**RFB-2024-56**  
**Schenectady County Public Works Garage Building and Sign Shop Project**

**ADDENDUM #5**

Date: 11/12/2024

1. Revised Drawing E-301

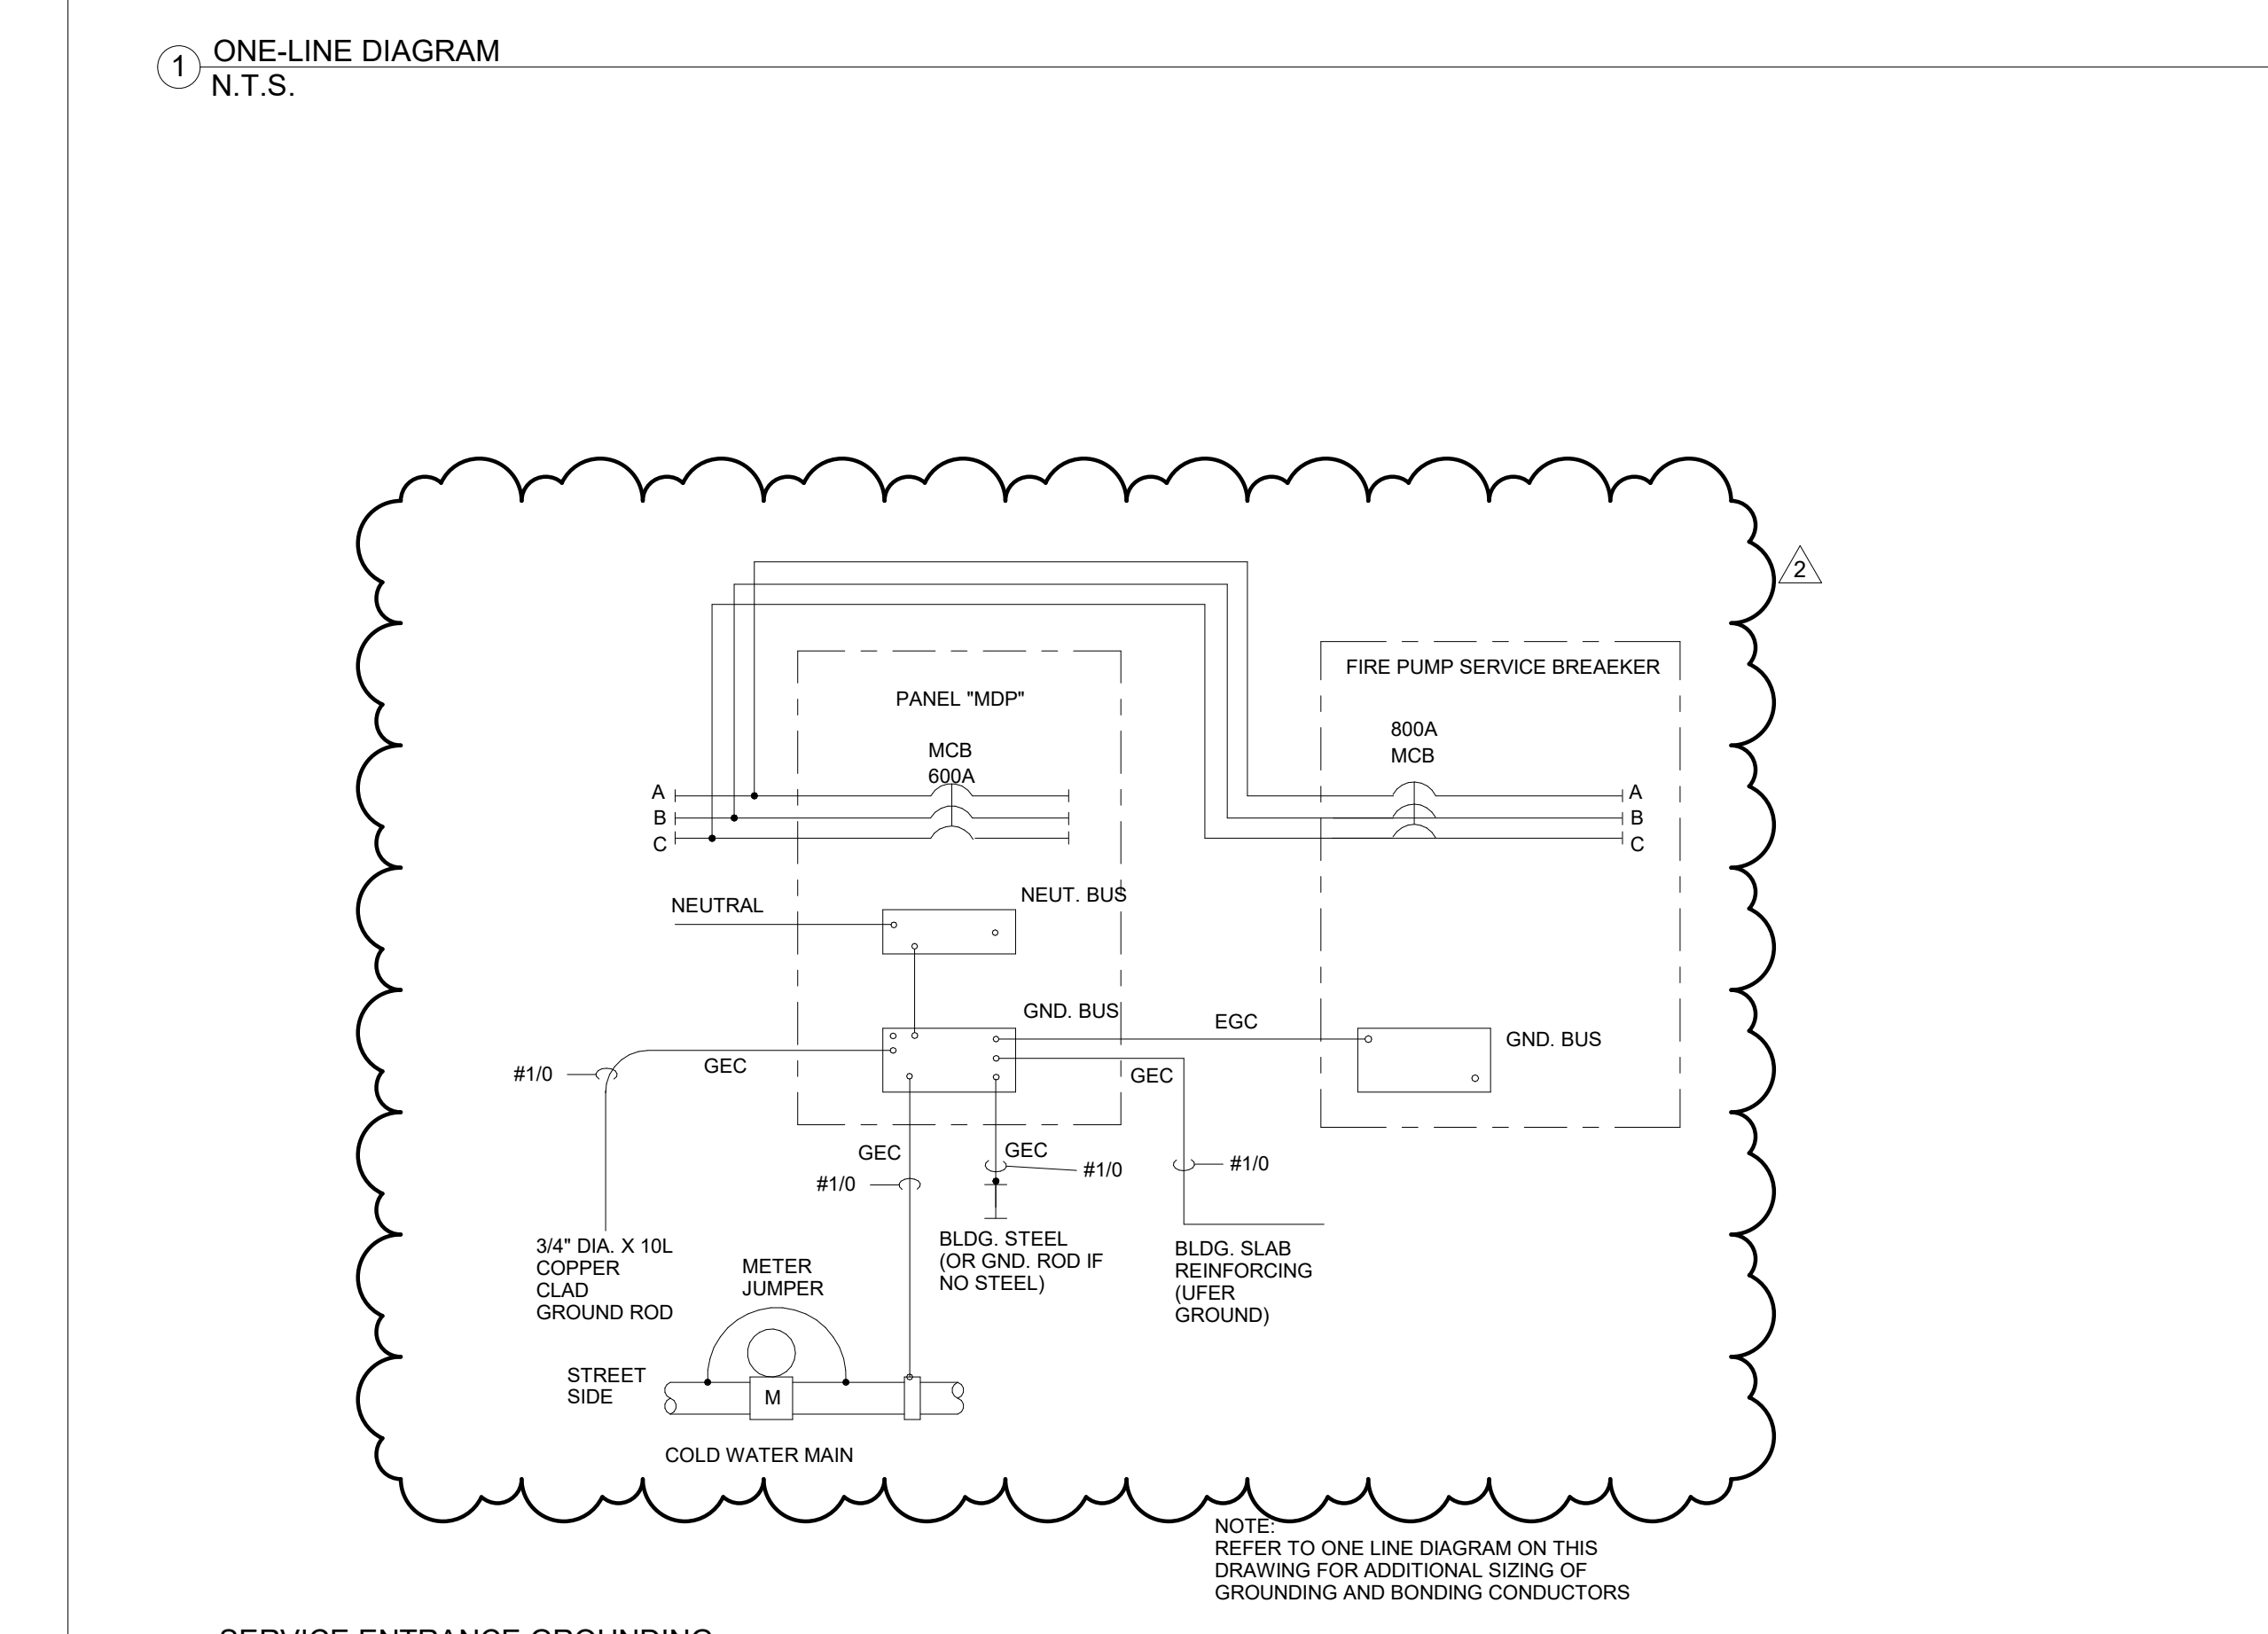
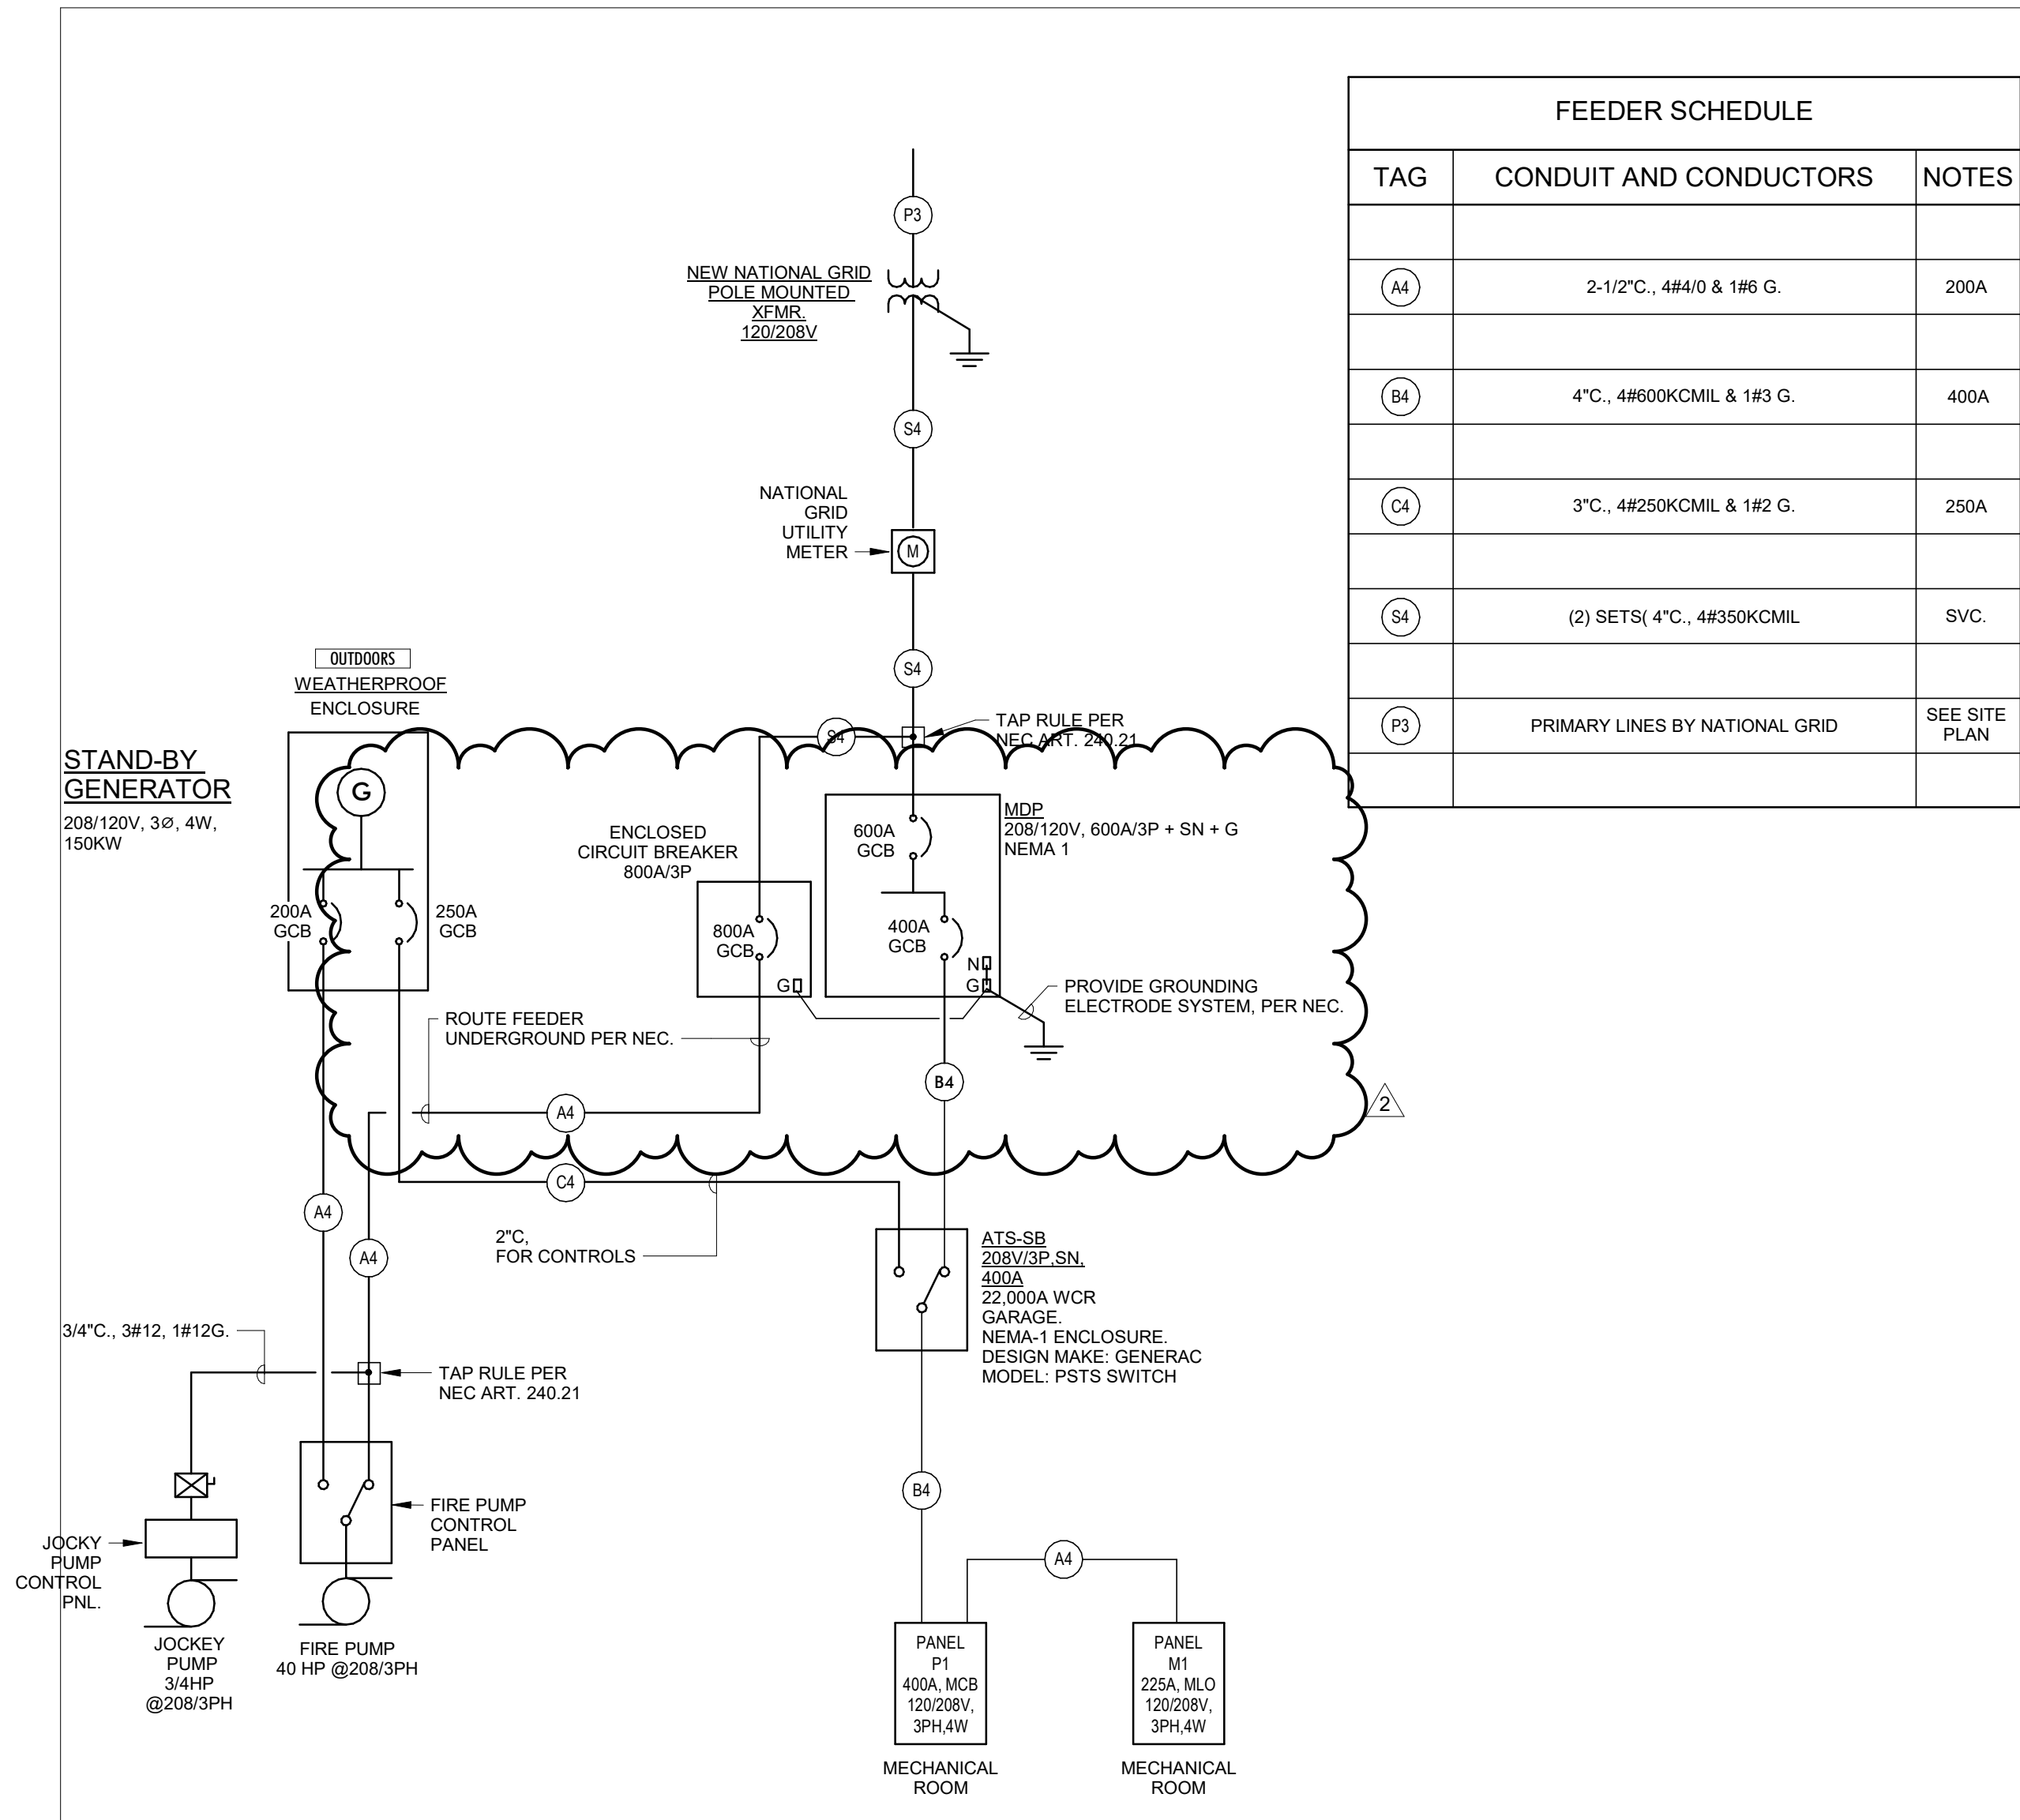
- 
2. Drawing E201 Panel Schedule P1 says to feed panel M1 with 3/0 conductors, however the one-line diagram on E-301 says 4/0 conductors. Which is correct?

- a. The primary wiring on this one-line shows it is provided by the EC, however drawing E002 detail #3 says its by the utility company. Which is correct?

- i. **Answer: All Primary wiring shall be by National Grid.**
- b. This shows a 600A service from National Grid. This would require instrumentation metering however a CT enclosure is not shown. Is this something that should be provided by the EC, and where would it be located?

- i. **Answer: E.C. shall provide CT cabinet at same location as meter indicated on power plan**
- c. Does the MDP need to be rated for 1000A with a 600A service feed?

- i. **Answer: No. Revise to 600amp.**
- d. After the tap of the service feed this ECB is 800A. Both the line side and load side (A4) are undersized for this application. Is the ECB 800A correct?

- i. **Answer: 800amp rating is required by NEC Art 695, breaker is sized for fire pump lock rotor amps.**
- e. The Standby Generator Says NIC. What is the intention for the EC in providing conduits and conductors to this location, leave coils of wire in this location?

- i. **Answer: Standby Generator is included. See revised E-301**
- f. The conduit between the Generator and ATS calls out a 3" conduit with conductors but it also noted as a 2" conduit for controls. Is this 2" conduit in addition to the 3" conduit?

- i. **Answer: The 3"C is for the feeder, and the additional 2"C is for the generator controls wiring.**
- g. There isn't a ground electrode system shown after the tap of the service conductors prior to the MDP where the ground would derive from. Detail #4 does not correspond to the new one-line.

- a. **Answer: 4/0 Conductors are correct. Panel Schedule M1 revise circuit conductors on branch circuit.37, 39 41 to 4/0 to match one line diagram.**
3. Addenda #4 Drawing E-301 Detail #1:

- i. **Answer: See revised detail 4, E-301.**
4. Can specifications be provided regarding which type of cord reel will need to be provided?
- a. **Answer: Refer to E-001**
